ADDENDUM NO. 1

March 19, 2025

School District of Haverford Township | Coopertown Elementary School Renovations & Additions
CRA Project No. 3758

CR

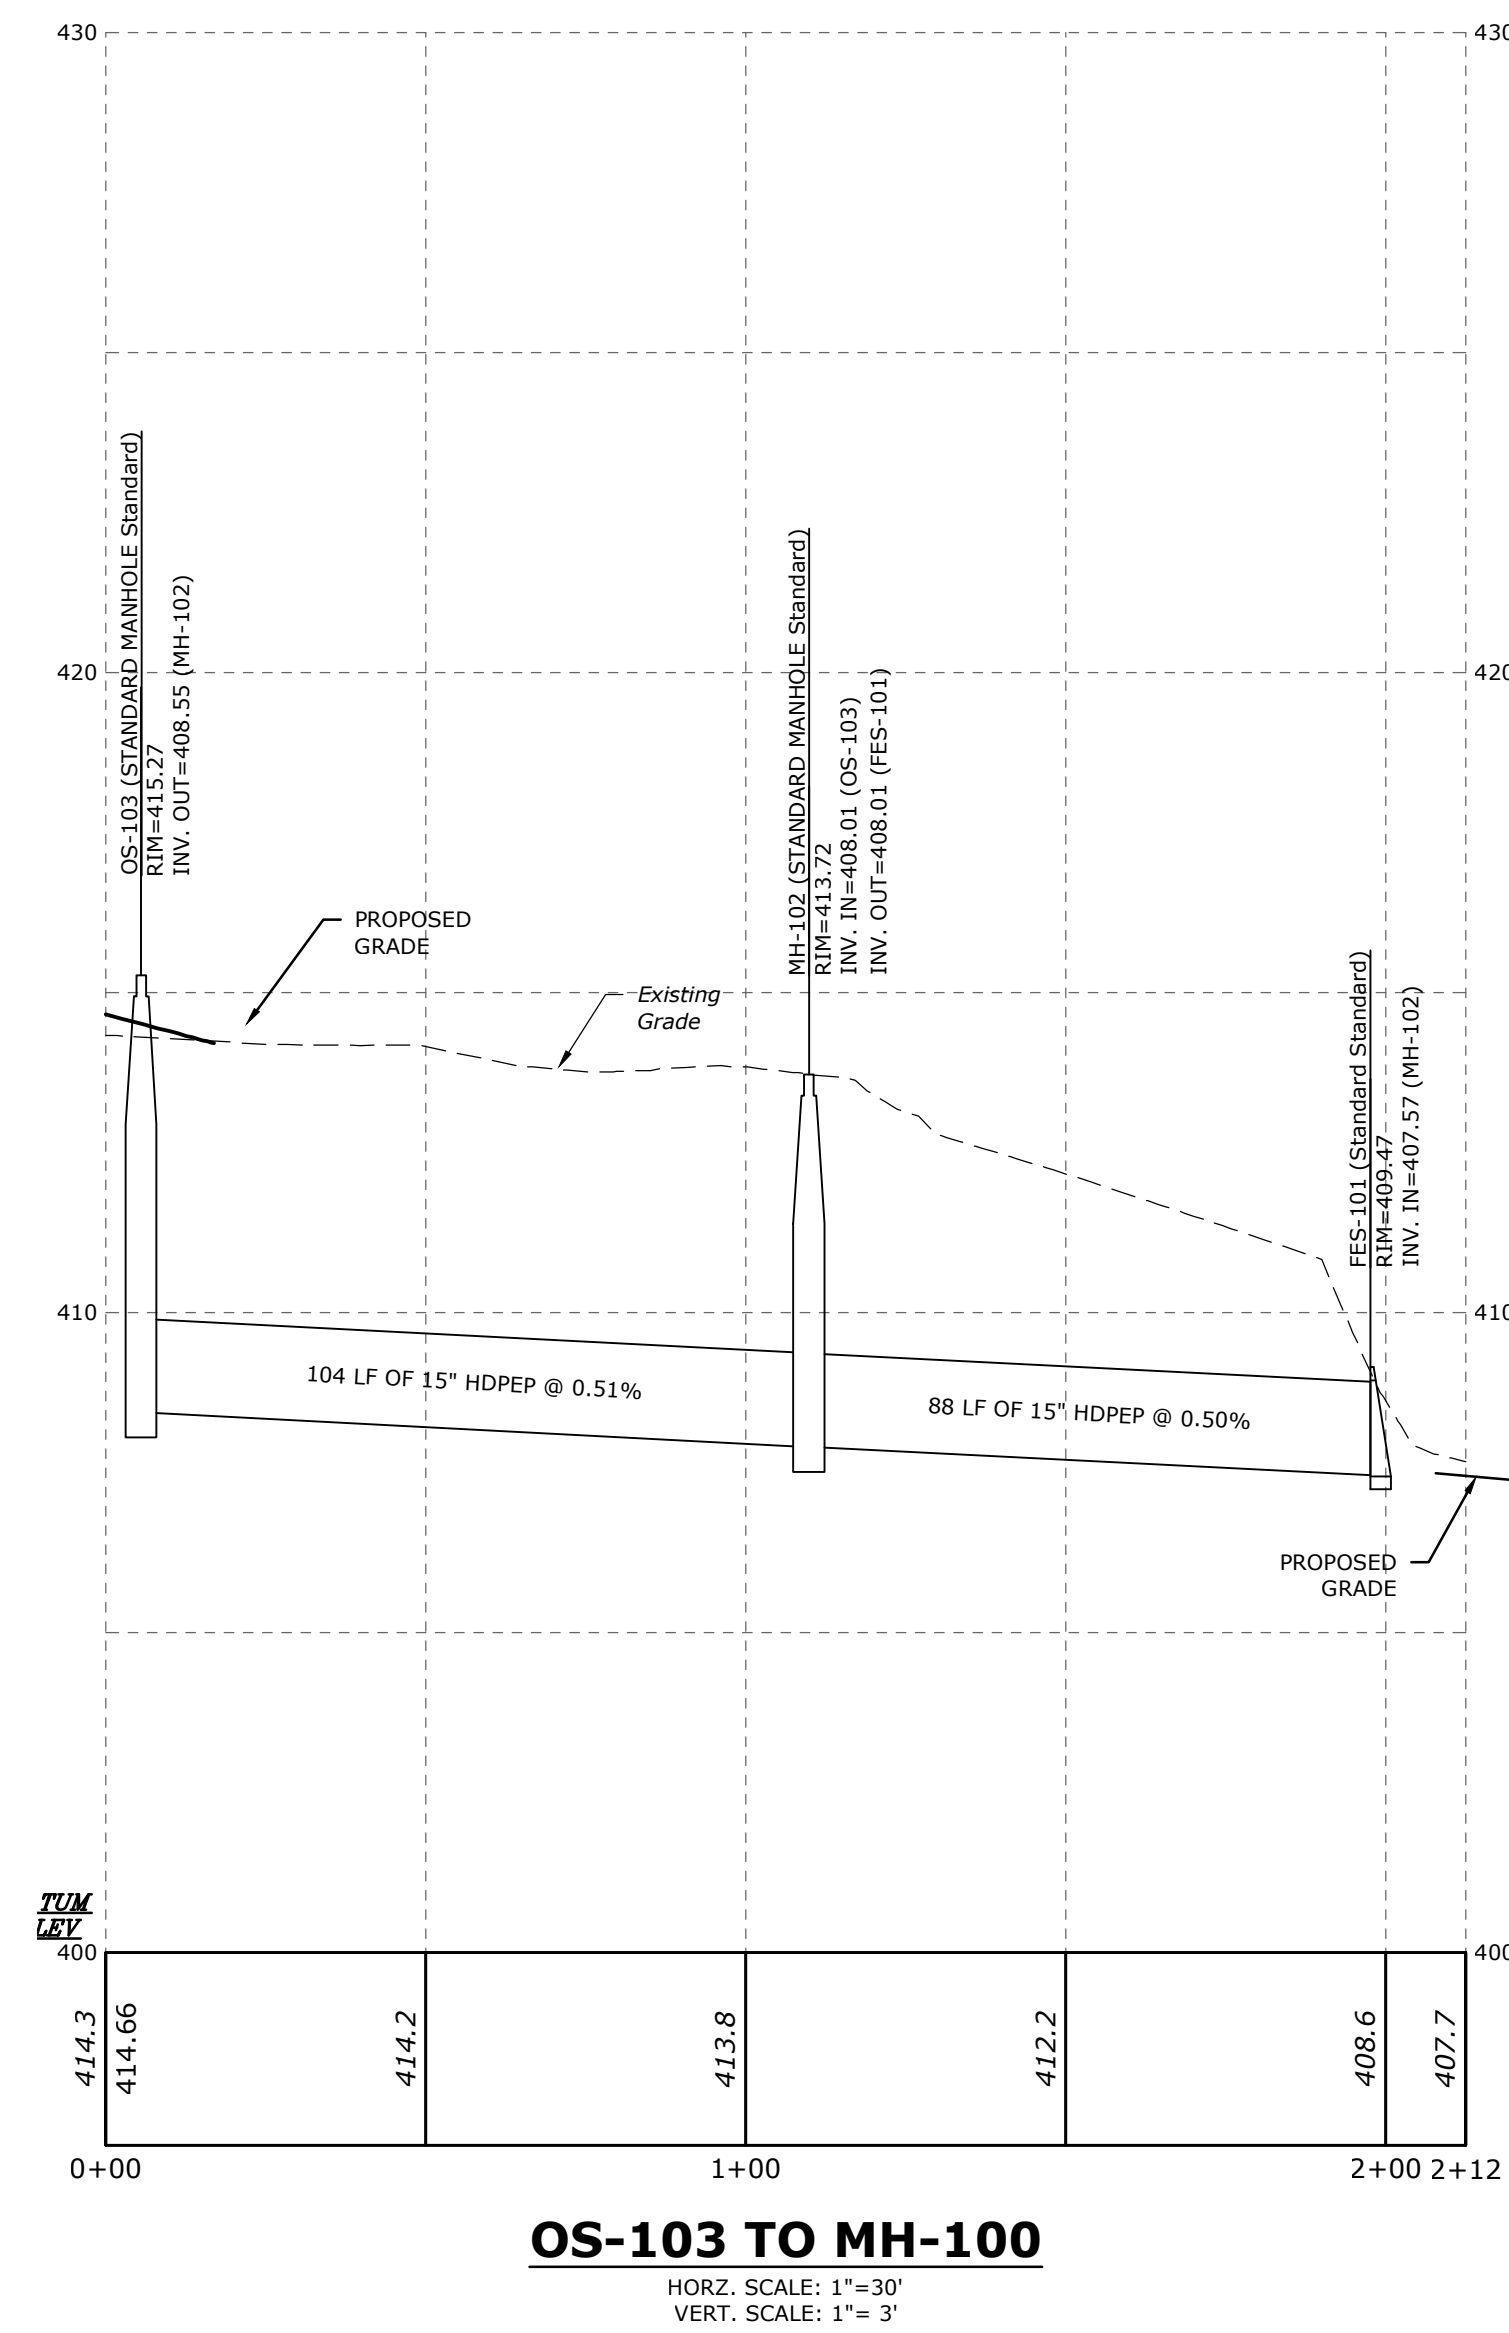
1. Move trees away from sidewalk.
2. Add tree fence protection
3. Revise Limits of Disturbance near flagpole

C-302

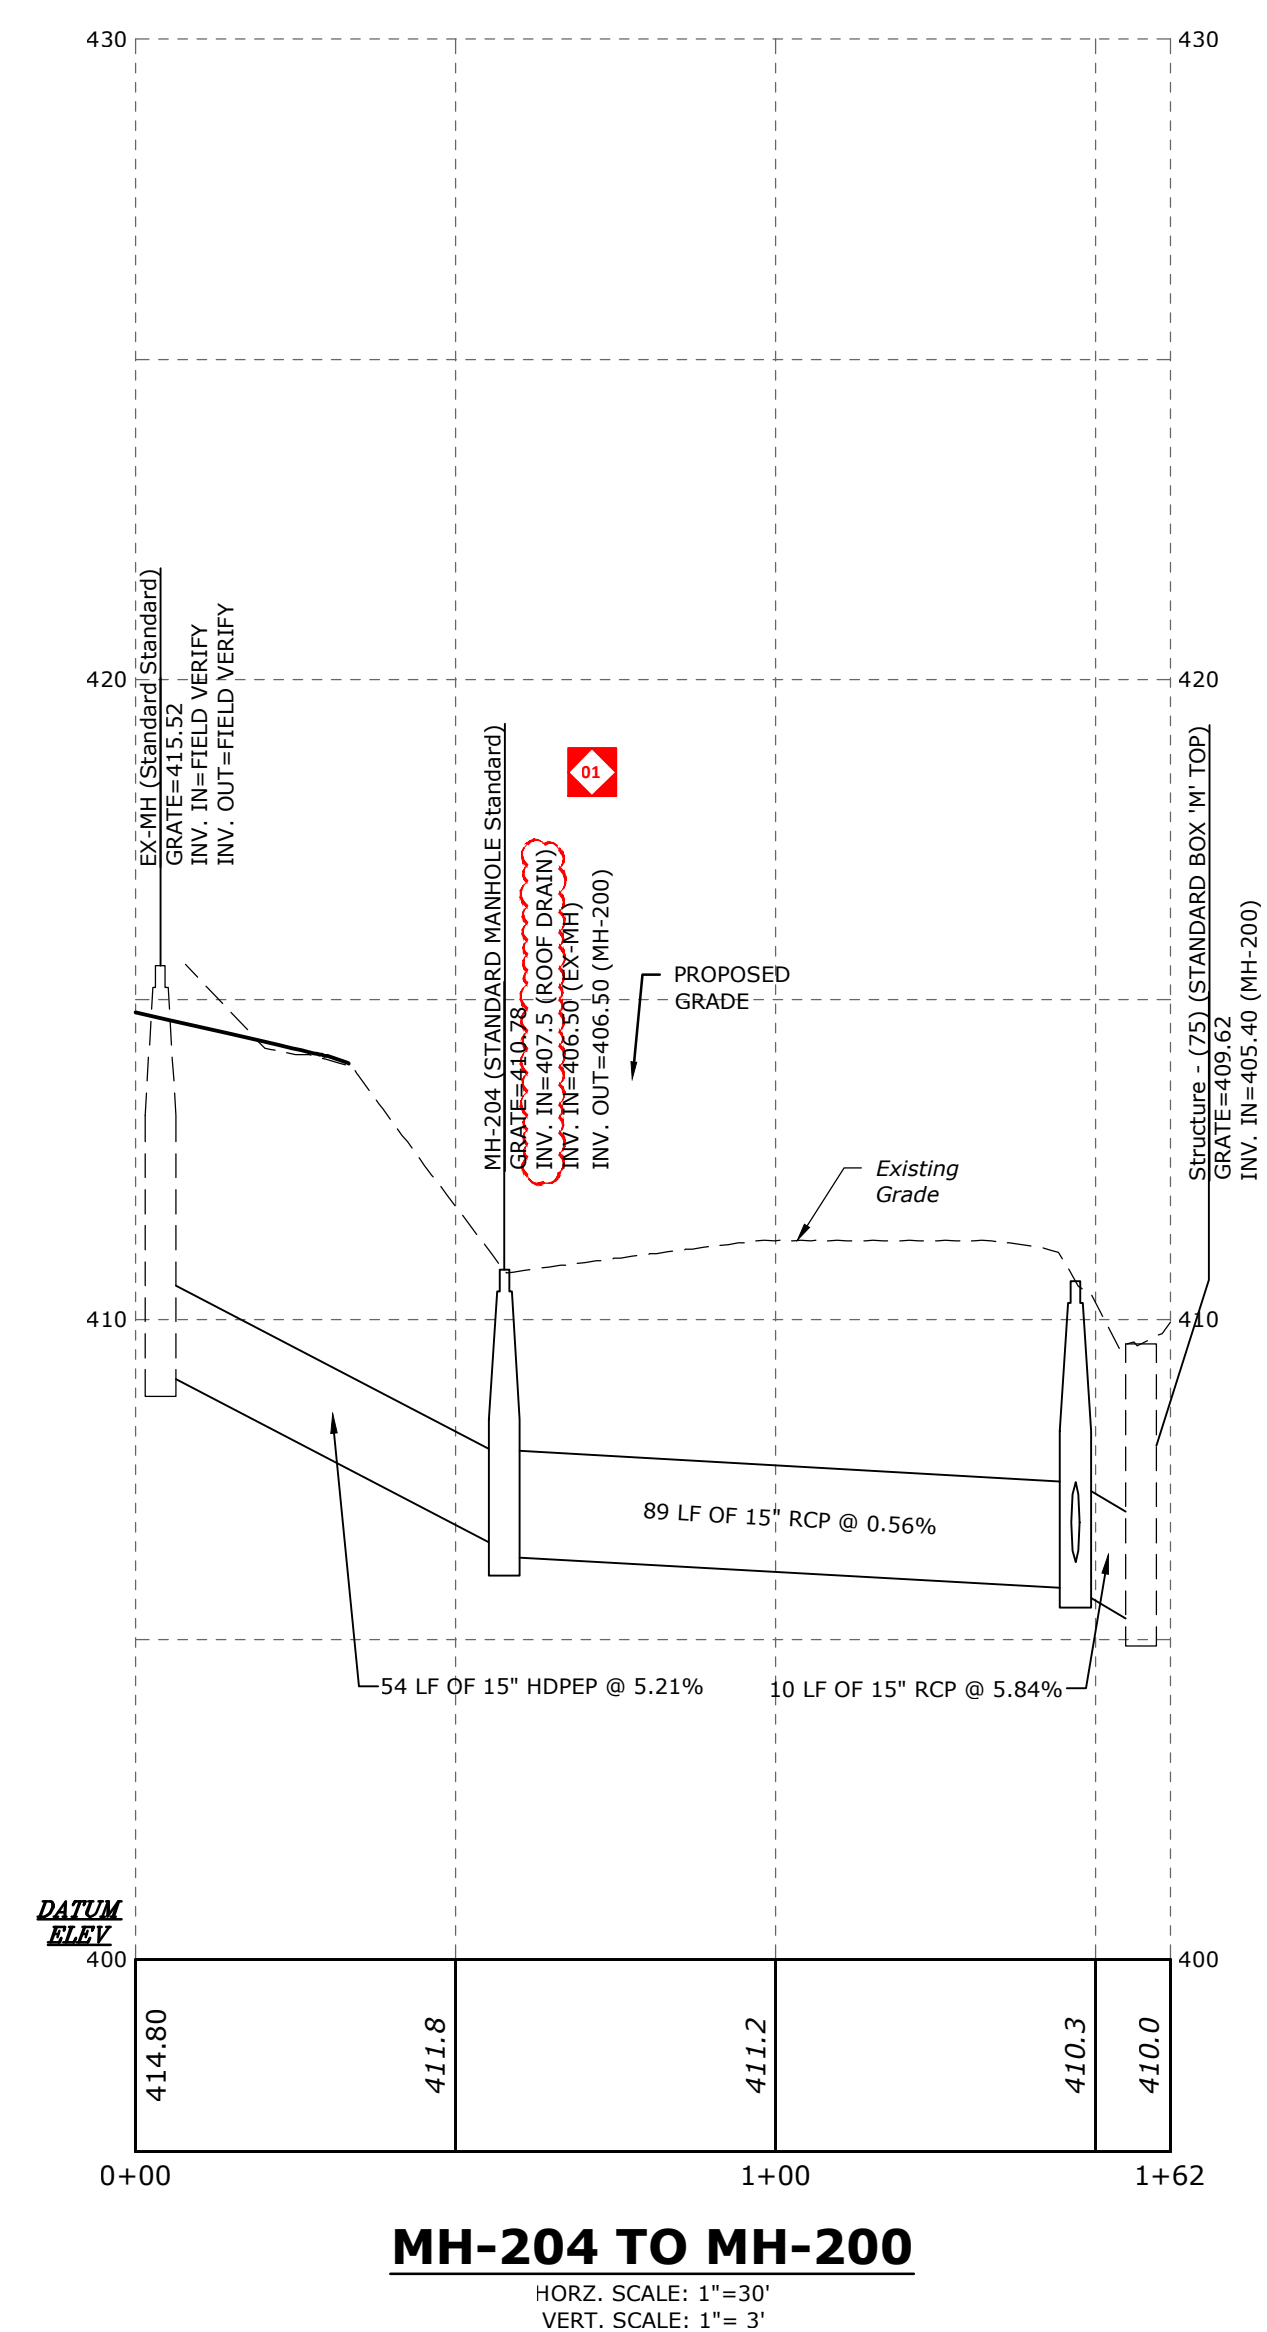
1. Add storm profile YD-2 to Y-1.

EXTERIOR ELEVATIONS	PROJECT 3758
PLOT SCALE: As indicated	A2.5
FILENAME:	
DATE:	MARCH 10, 2025

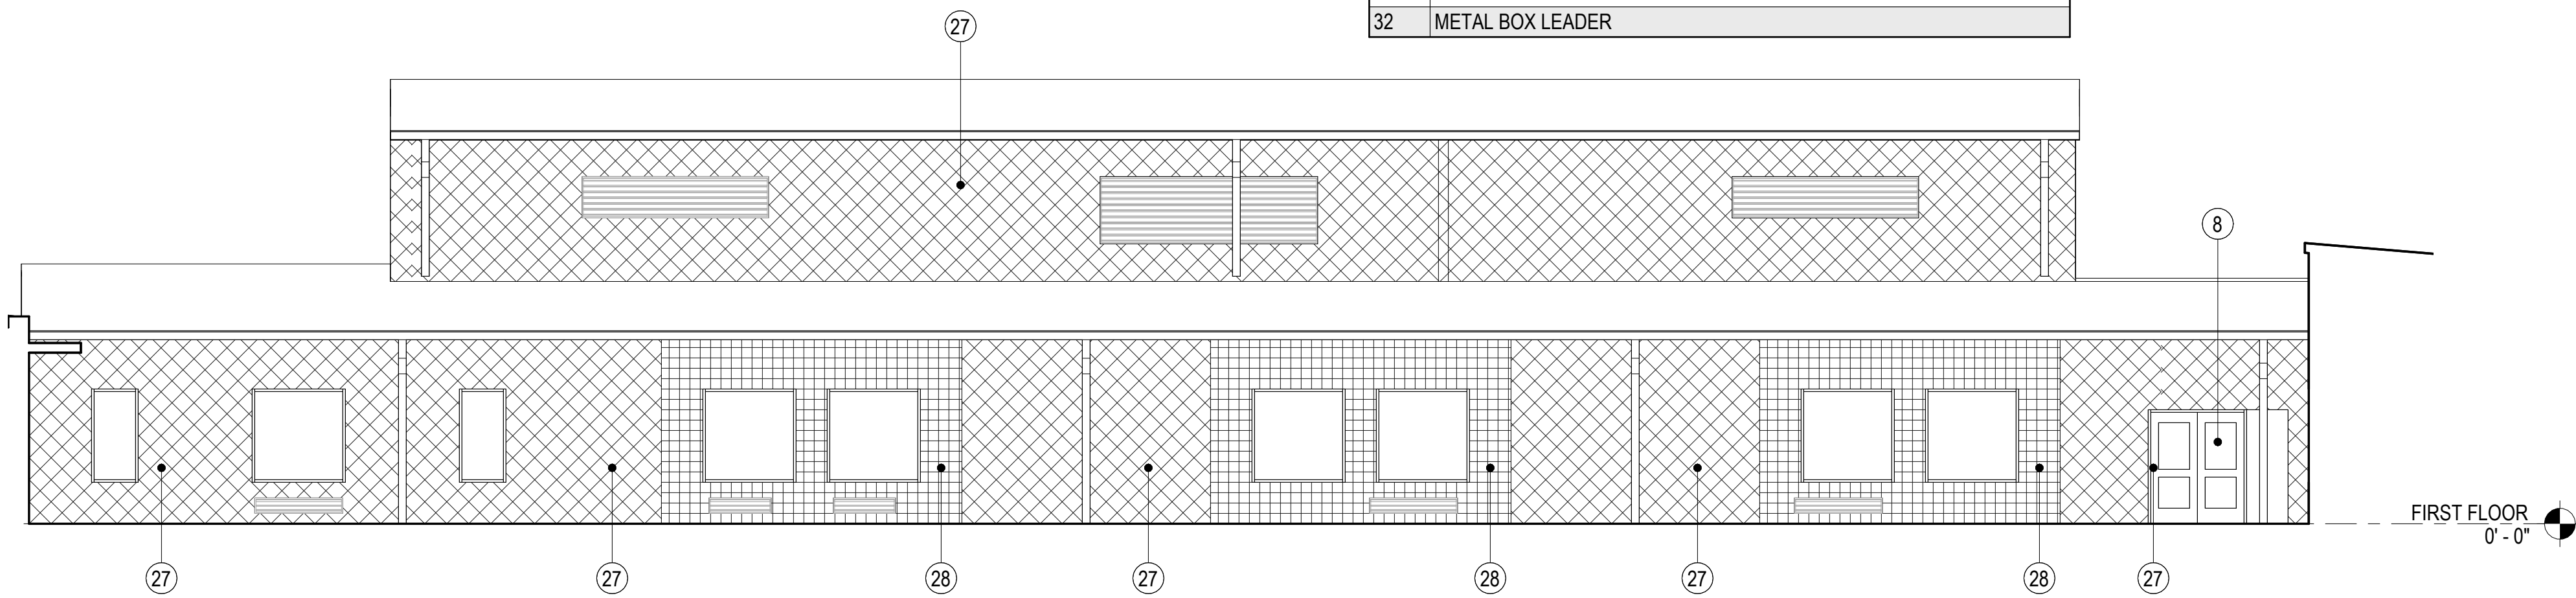
1. ADD - Box leader and associated keynote
